SUBJECT: Transmittal of Responses to AP1000 DSER Open Items

**AP1000 Design Certification Review
Draft Safety Evaluation Report Open Item Non-Proprietary Responses**

DSER Open Item Number: 3.7.2.3-1 (Revision 1)

Figure 3.7.2.3-1-1: ASB Stick portion of NI combined model

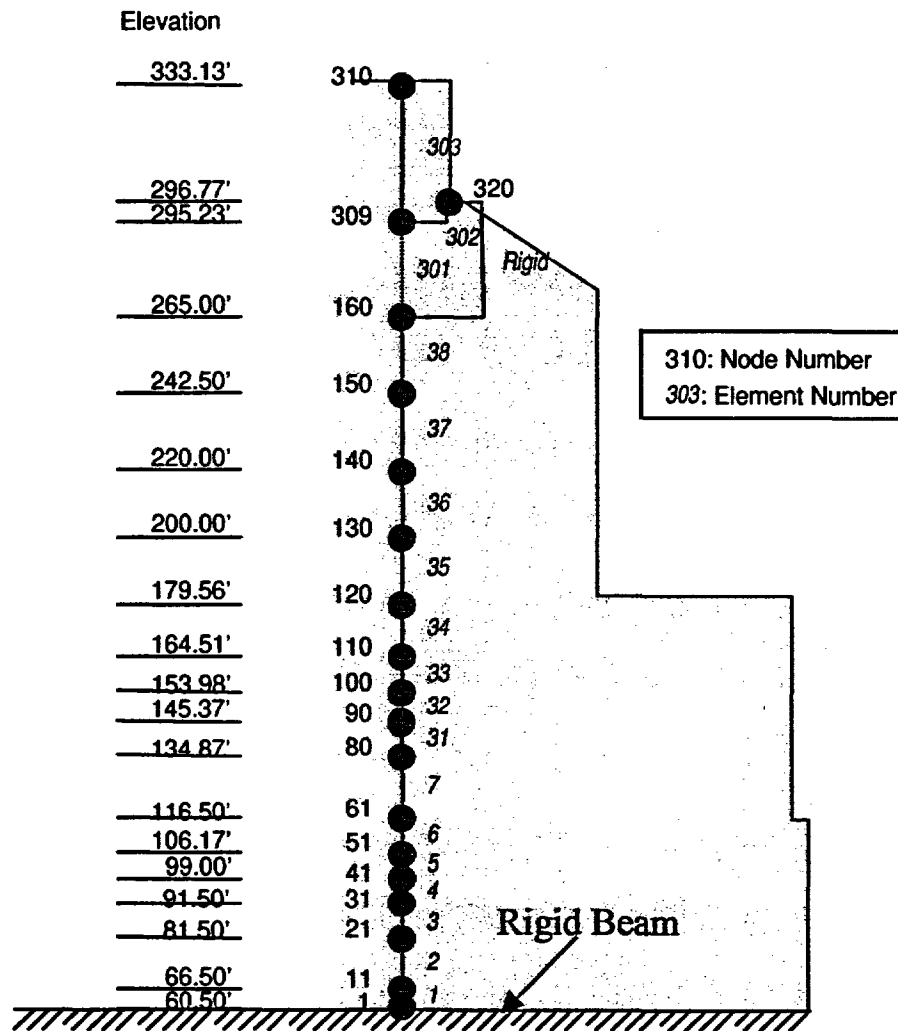
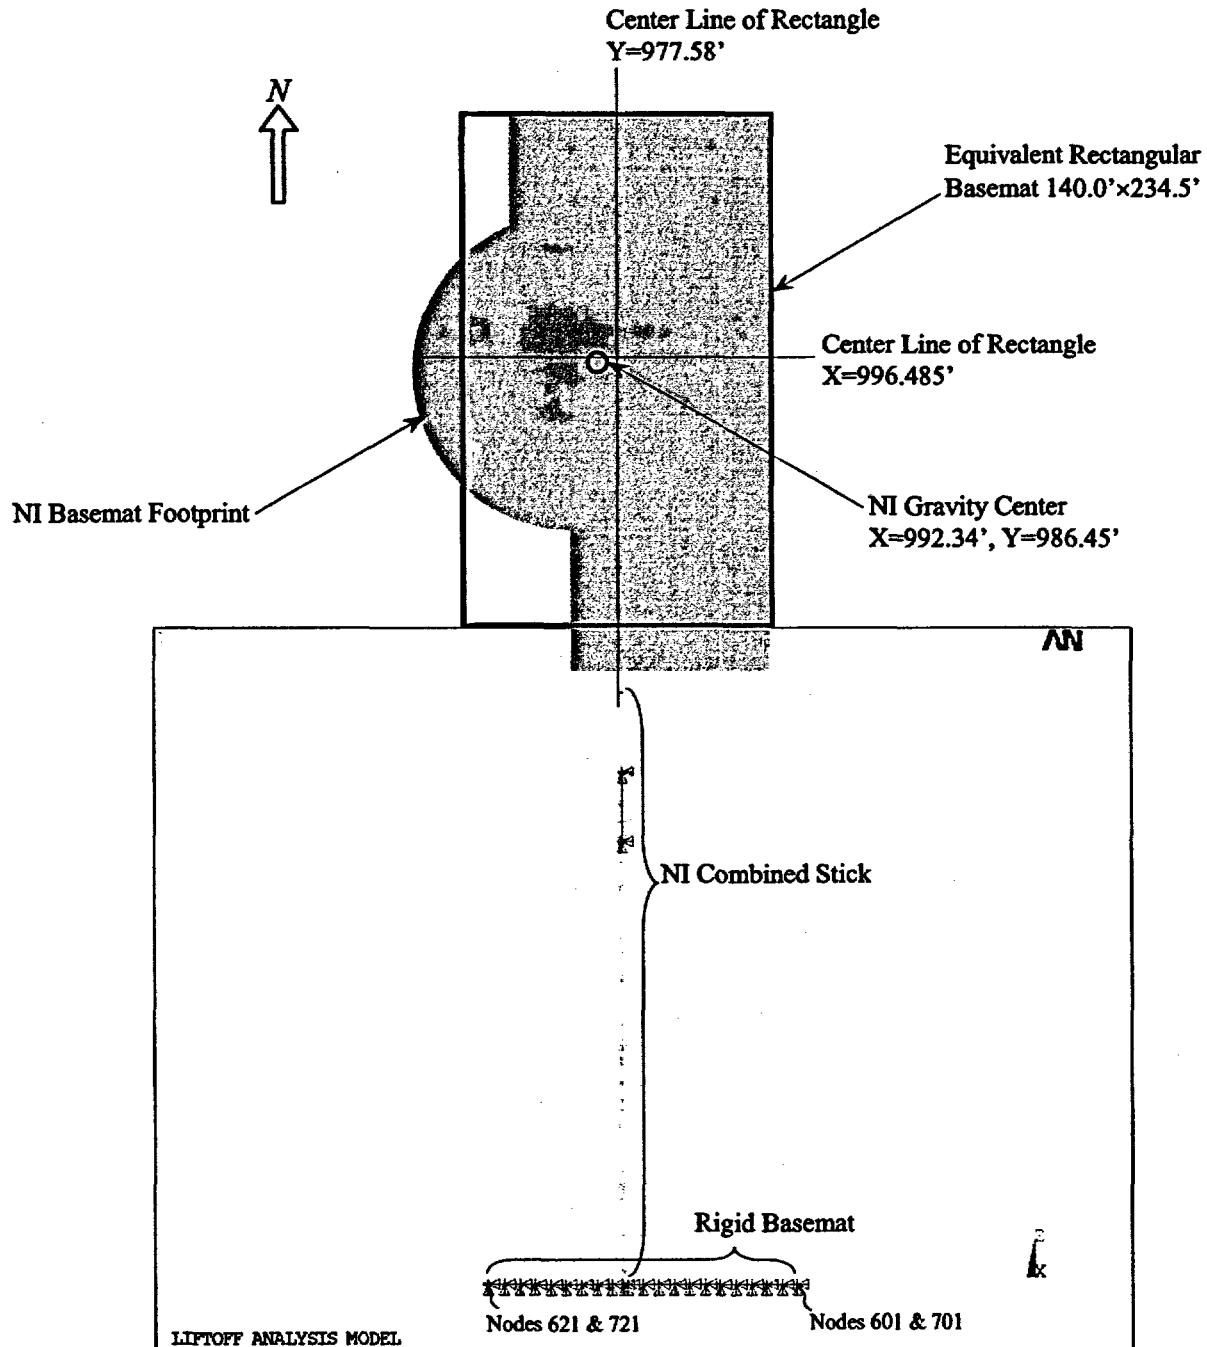
During the audits conducted on November 12, 2002, and April 2, 2003, the staff discussed with the applicant the development of the dynamic model of the NI structures and reviewed the applicant's analysis reports based on both 3D lumped-mass stick model and 3D finite element model. The seismic analysis results from the 3D finite element model of the coupled auxiliary/shield building shows net tension in the shield building wall. This phenomenon suggests that during the postulated seismic event, parts of the basemat will lift up from the rock surface resulting in changes in the basemat stresses and reduction of shear wall stiffnesses due to reinforced wall cracking. As a result of the detailed review of the seismic modeling approach and analysis methods, the staff identified an issue that the assumptions of uncracked reinforced concrete walls and fixed-base foundation may become invalid. With this finding, the applicant was requested to provide justification to show that the current seismic analysis results used for the design of the NI structures, systems and components are reasonable and acceptable.

In resolving this issue, the staff, during the meeting conducted on April 2, 2003, explained its concern and expectation to the applicant regarding the significance of uplift due to seismic excitation of the NI and the effect of reduction of stiffness of shear walls. The discussion reached the following conclusions:

- The applicant will use East-West lumped-mass stick model of the NI structures supported on a rigid plate with nonlinear springs that transmit reactions in horizontal and vertical directions to simulate the foundation contact area, and perform a seismic time history analysis (the nonlinear springs will be in action only when the rigid plate is in contact with the subgrade). The results of this seismic time history analysis will be compared against the peak accelerations and the floor response spectra at the lumped mass node points obtained from the current three dimensional model analysis without the uplift consideration. If the comparison shows differences, the applicant should evaluate the significance of these differences and their effects on the current seismic design.

The effect of liftoff was evaluated using an East-West lumped-mass stick model of the nuclear island structures supported on a rigid basemat with nonlinear springs. This model is shown in Figure 3.7.2.3-1-1 and Figure 3.7.2.3-1-2. The liftoff analysis model consists of the following two elements:

The size of the equivalent rectangular basemat having the same overturning inertia as the nuclear island basemat is 140.0' × 234.5'. The basemat is modeled as a rigid beam, using 20 elements each 7 feet apart. Hard rock with a shear wave velocity of 8000 feet per second is modeled as horizontal and vertical spring elements with viscous damping at each node of the rigid beam. As shown in Figure 3.7.2.3-1-2, the NI combined stick is attached to the rigid basemat at the NI gravity center, which is about 9 feet from the center of the rigid basemat. In north-south direction, the stick is fixed at the bottom (EL. 60.5'). The stiffness properties of the

ASB and CIS in the NI combined stick model are reduced by a factor of 0.8 to consider the effect of cracking as recommended in Table 6-5 of FEMA 356. This model is a simplified version of the model used in the analyses described in Section B of this response. The three sticks are concentric instead of eccentric and the reactor coolant loop is included as mass only.

FIGURE 3.7.2.3-1-11: ADDING SOIL MASS ELEMENT

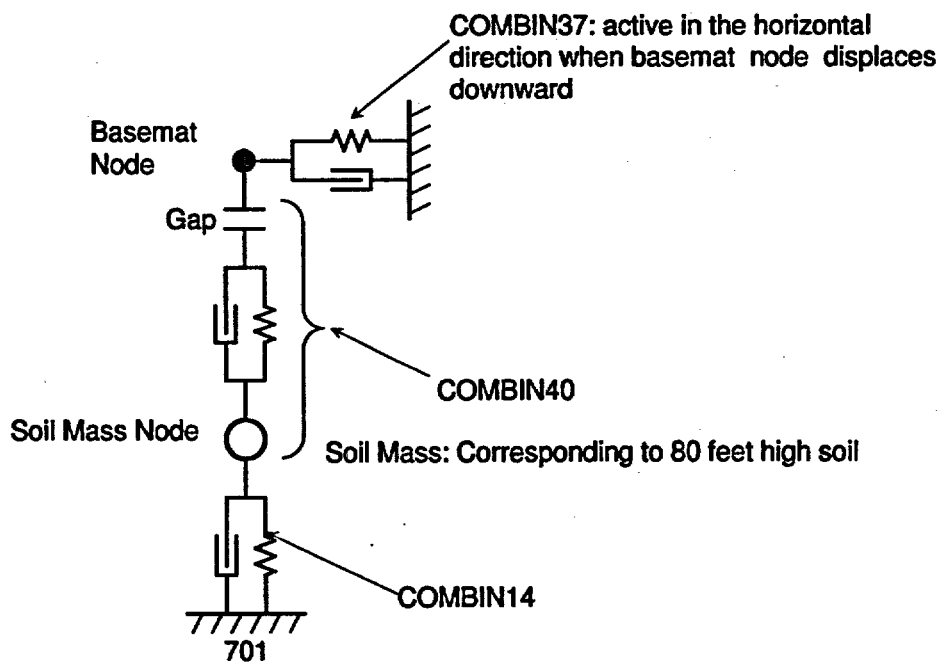
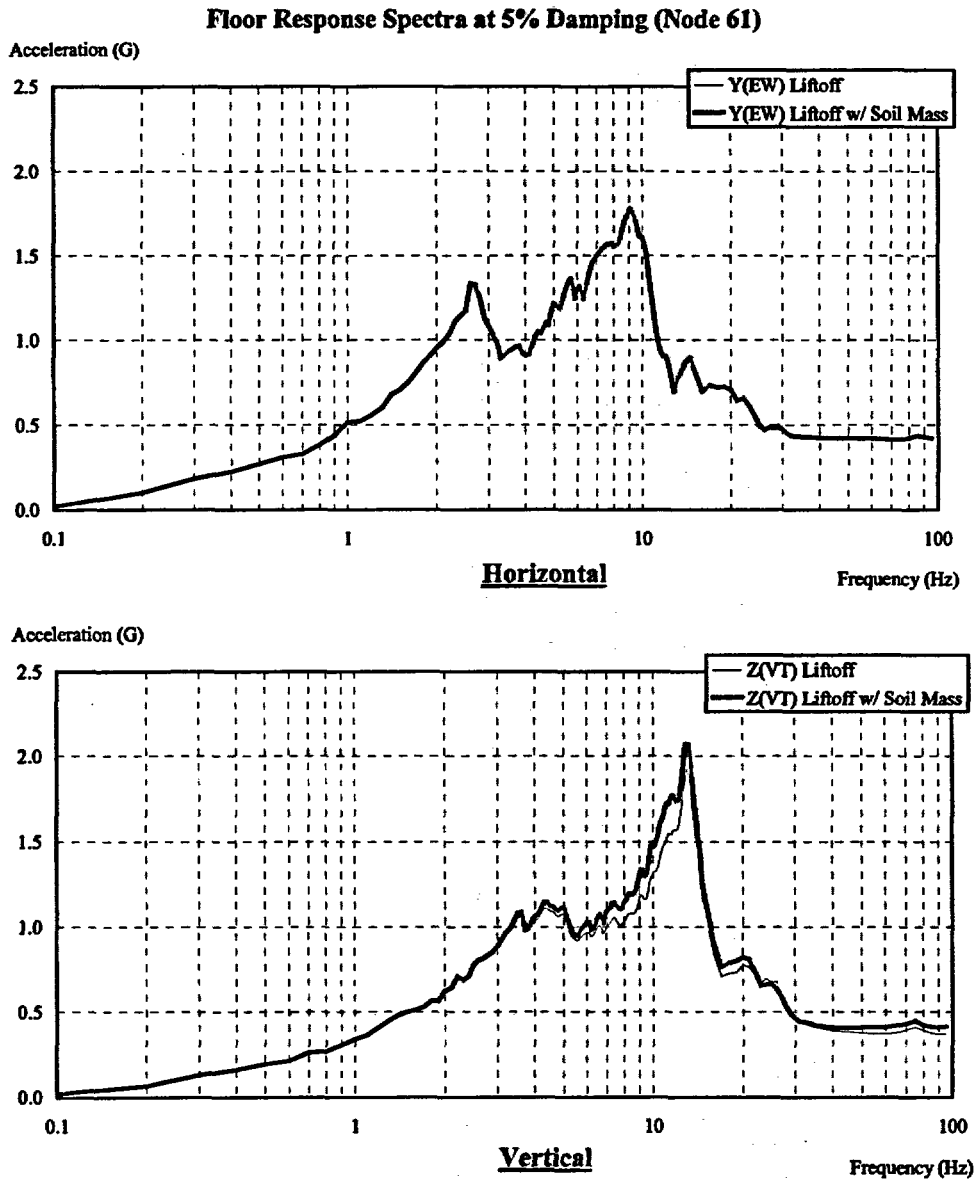
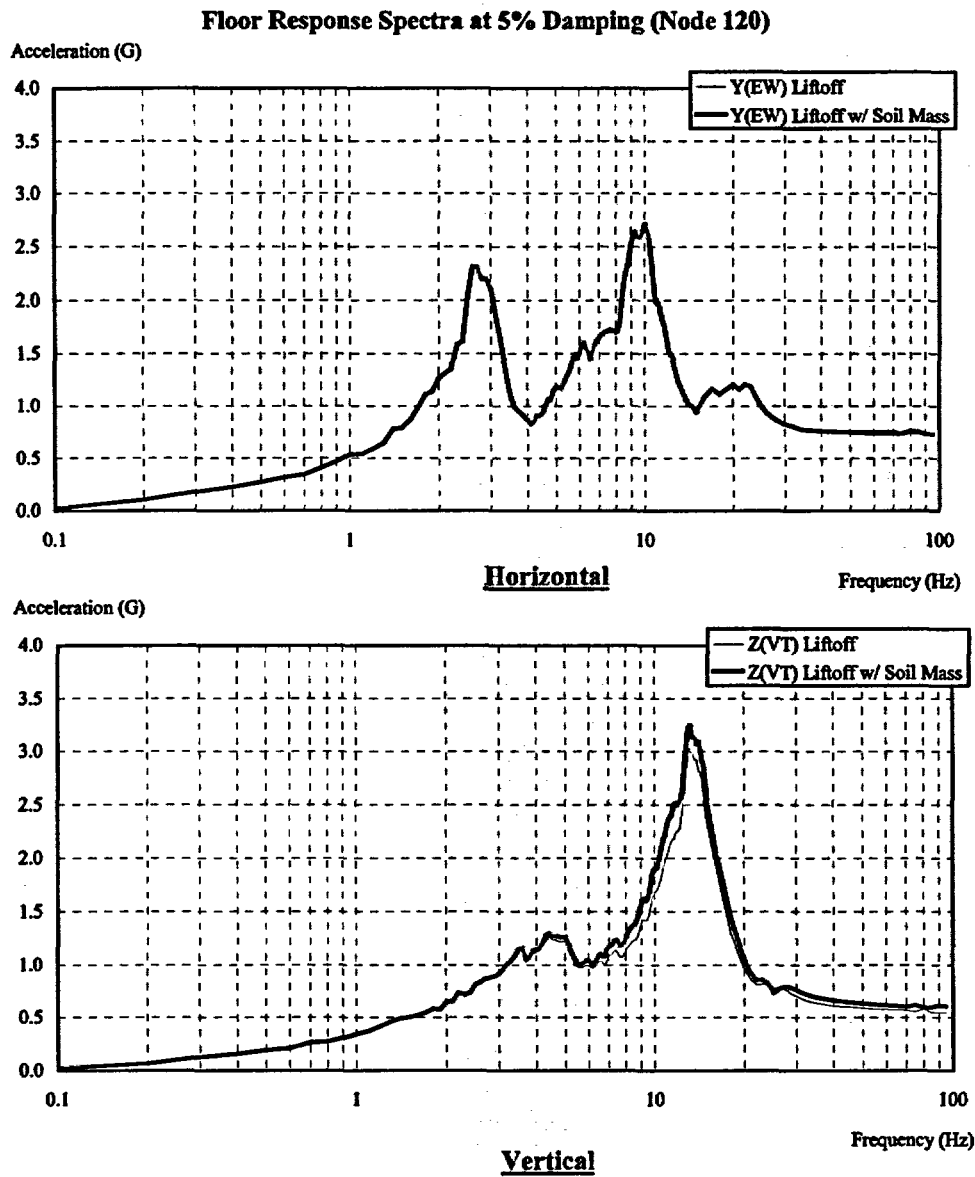
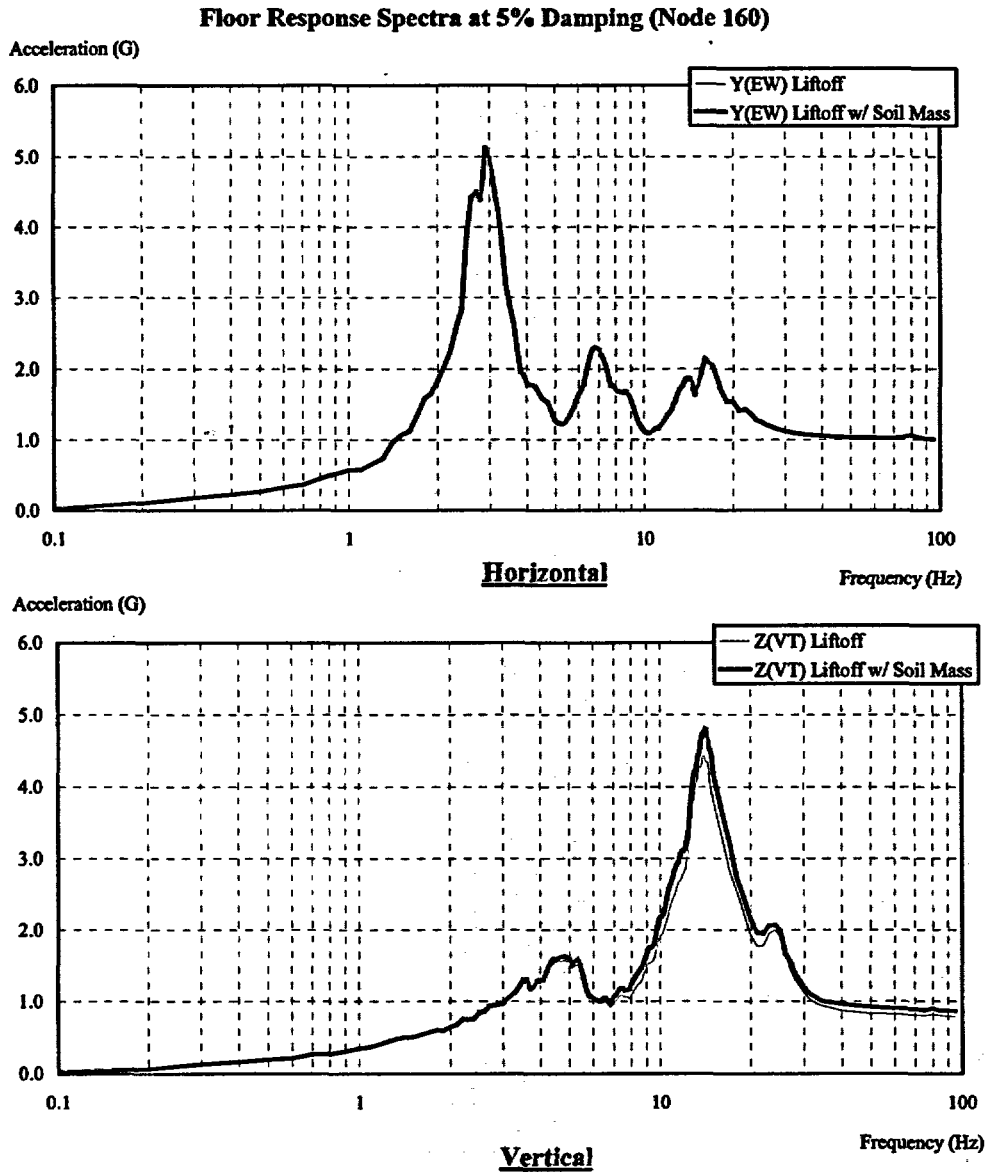
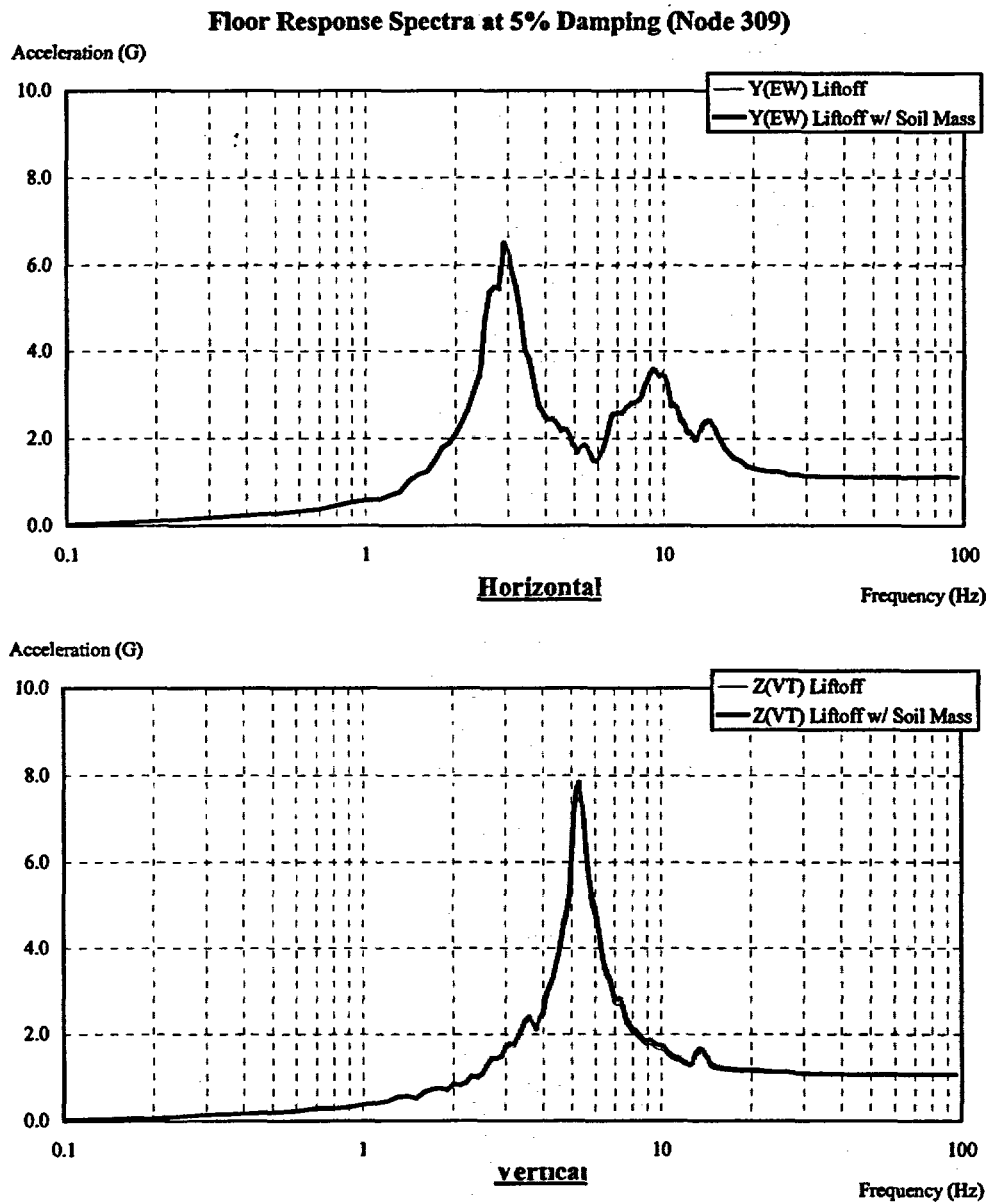
During the telephone conversation of mid August, 2003, the NRC staff commented that the "slapping" phenomenon that occurs during liftoff was not being addressed fully because the existing liftoff model did not include independently acting soil masses.

In order to investigate the effect of soil mass, gap elements representing soil 80 feet deep were added to the existing liftoff model as shown in Figures 3.7.2.3-1-11. The horizontal and vertical floor response spectra at representative elevations of the auxiliary and shield building are shown in Figures 3.7.2.3-1-12 through 3.7.2.3-1-15. The results show that the soil mass effects are insignificant in the horizontal direction. These effects are also insignificant in the vertical direction at the higher elevations, and are very small at the lower elevations.

Figure 3.8.5.4-1-1
Free-body Diagram for Containment Internal Structures Overturning Evaluation

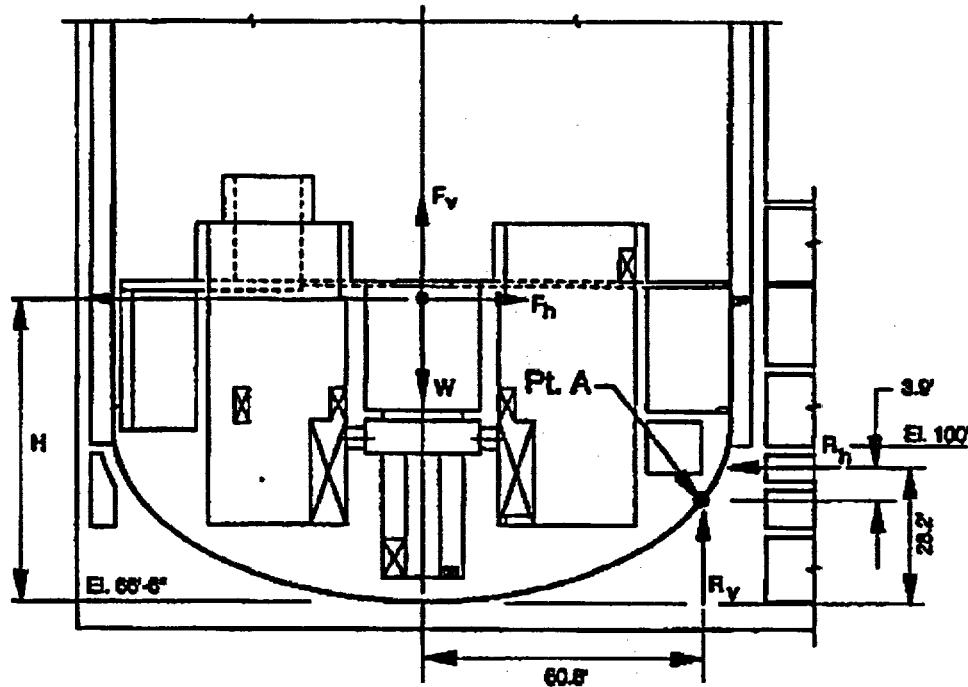
In its review of DCD Tier 2 Section 3.8.5.4, the staff determined that the potential uplift and slapping back of the containment internal structures foundation on the basemat through the steel containment vessel during a seismic event could affect both the seismic design loads and in structure response spectra for all structures, systems and components associated with the containment internal structure, and could also affect the seismic response of the steel containment shell. In RAI 220.021, the staff requested the applicant to perform additional analyses to demonstrate how the uplifting effect will be addressed, and how the uplifting effect on the seismic analysis results will be used for the design of the containment and containment internal structures. This is Open Item 3.8.5.4-1.

The bottom head of the containment vessel rests on the nuclear island basemat. The containment internal structures basemat rest within the bottom head. There are no shear studs or anchors designed to transfer loads tangential to the vessel surface. The interface is designed to transfer load in compression and friction. The configuration is identical to the AP600 and the stability evaluation shown in Figure 3.8.5.4-1-1 follows the AP600 methodology described in the AP600 response to RAI 230.47.
